Subject: Docket Number 070-03098
Duke Cogema Stone & Webster
Mixed Oxide Fuel Fabrication Facility
Response to NRC Request for Additional Information on MOX Project
Quality Assurance Plan (MPQAP) Revision 2

Reference: Letter, Johnson to Hastings, 19 June 2001, "Request for Additional Information
on the Duke Cogema Stone & Webster (DCS) Mixed Oxide Project Quality
Assurance Plan, Revision 2"

**RESPONSES TO NRC REQUEST
FOR ADDITIONAL INFORMATION
FOR THE DUKE COGEMA STONE & WEBSTER (DCS)
MIXED OXIDE (MOX) QUALITY ASSURANCE PLAN (MPQAP), REV. 2**

Figure 1-1: MOX Project Organization for Base Contract and Option 1

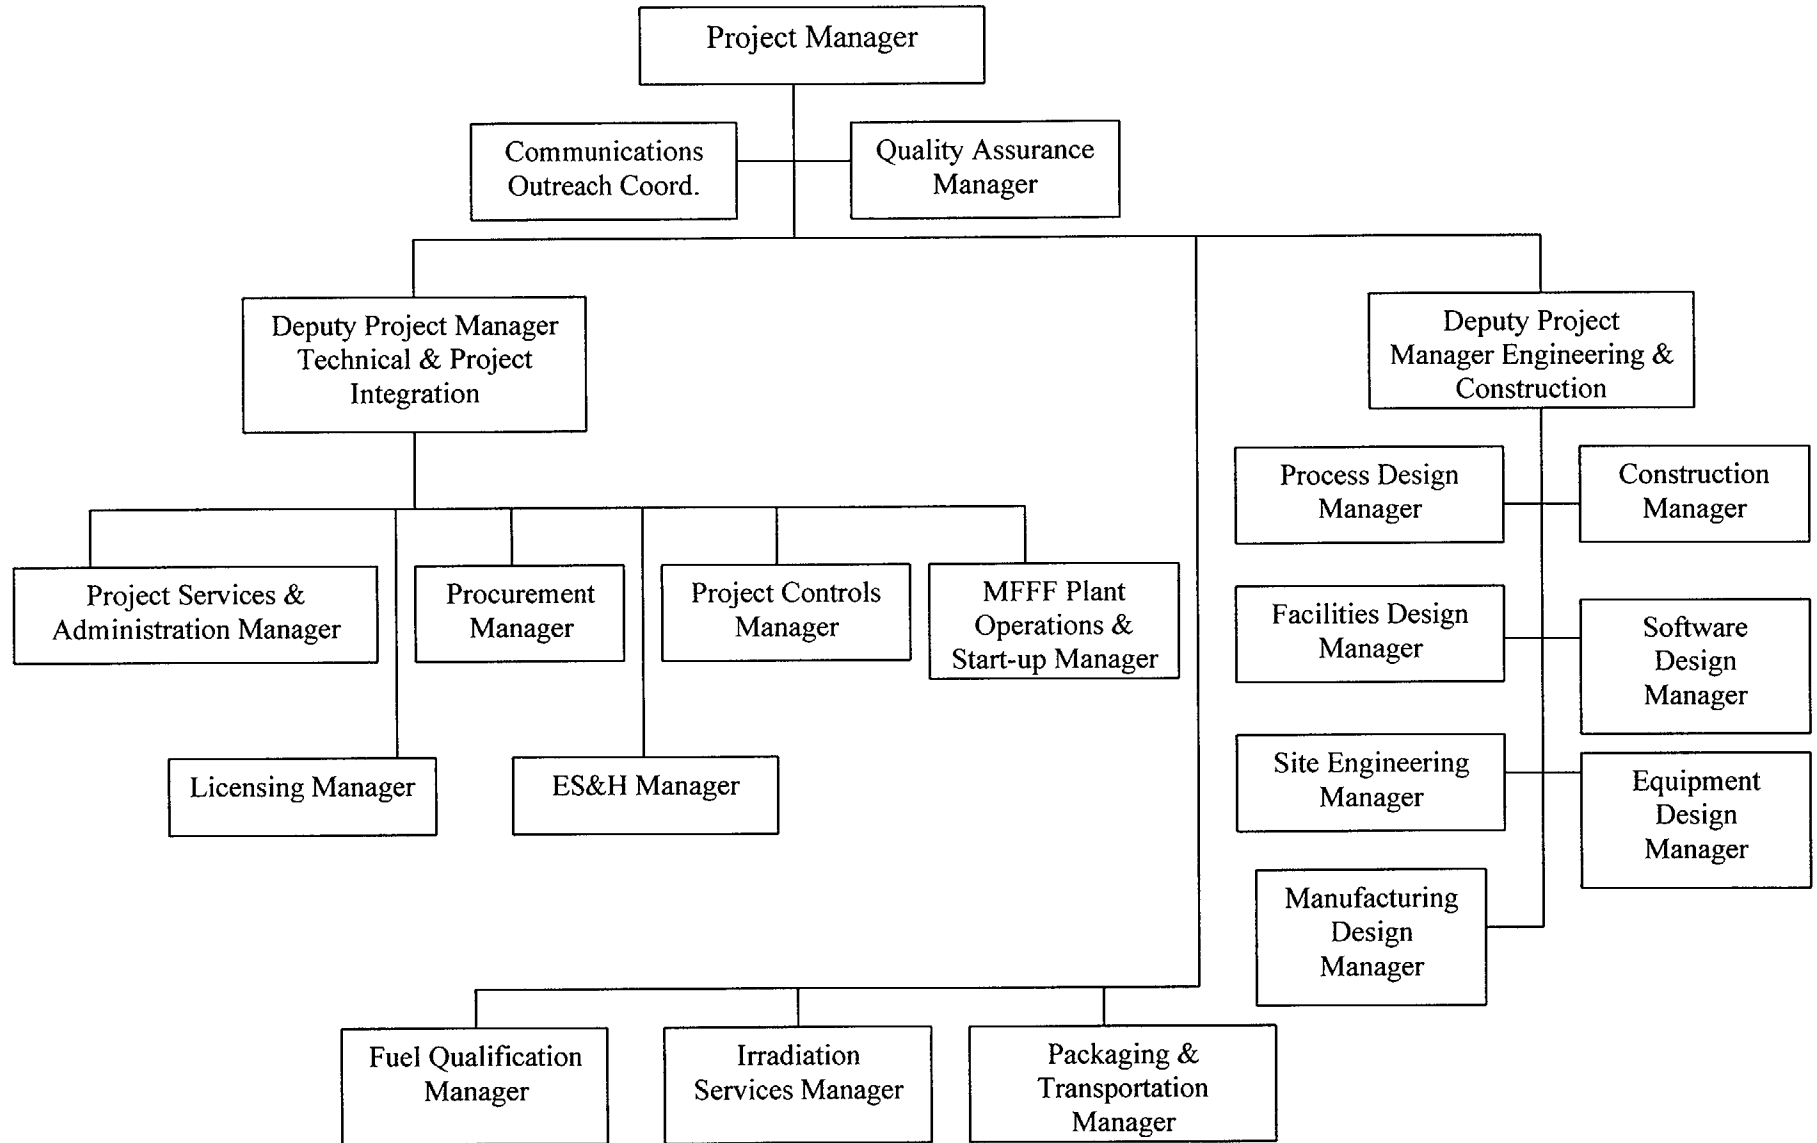
RAI Item 1: Provide a full description of the applicant's organization for construction. Identify the responsibilities and functions of all Duke Cogema Stone & Webster (DCS) and other quality assurance (QA), quality control (QC) or inspection organizations where construction activities are delegated.

The MPQAP has brief descriptions relating to "construction management," but does not address the actual construction responsibilities and interfaces. Clarify if there will be major delegation of work such as to an architect/engineer, a mixed oxide (MOX) plant constructor, an integration contractor, system suppliers, or other on- or off-site organizations. Where work is delegated, the responsibilities and functions of the DCS QA, QC, inspection and/or construction management organizations and those of the subcontractors should be identified. The authorities and responsibilities among the organizational groups and the means of communication should be addressed, including the DCS design and engineering functions and interfaces and those of the various contractors during construction. Organization charts should reflect the lines of responsibility and authority. Clear and unambiguous controls and communications, and responsibility and authority between the construction, equipment, and system suppliers and DCS design, engineering, project management, procurement, construction management, and QA, should be identified. All key management positions for construction activities should be adequately addressed. Specific activities such as inspection and testing of construction activities, equipment, and structures, systems, and components (SSCs) should be adequately addressed as to what organization performs them, and what, how, and by whom, QA controls and management measures are applied.

expertise. This is accomplished through a matrix organization representing all aspects of the construction process. The Construction Management organization provides oversight and management of the subcontractors and vendors that are subcontracted to execute specific construction work scopes. The organizational structure of the MOX Fuel Project during the construction phase is shown in Figures 1-1 and 1-2.

Revise MPQAP Section 1.2 Position Responsibilities to describe changes for support of construction to the project management organizational chart and specifically adding the construction management organization details for the Construction Manager, Resident Engineer, and CM Area Superintendents including roles, responsibilities and interfaces as discussed above. Also revise section 1.2.4.2 QA Manager to describe the oversight of construction subcontractors. Figure 1.0-2 will be replaced with Figures 1-1 and 1-2 of this response. Functions for each of the positions will also be added to Figure 1-1 similar to what was done with Figure 1.0-2.
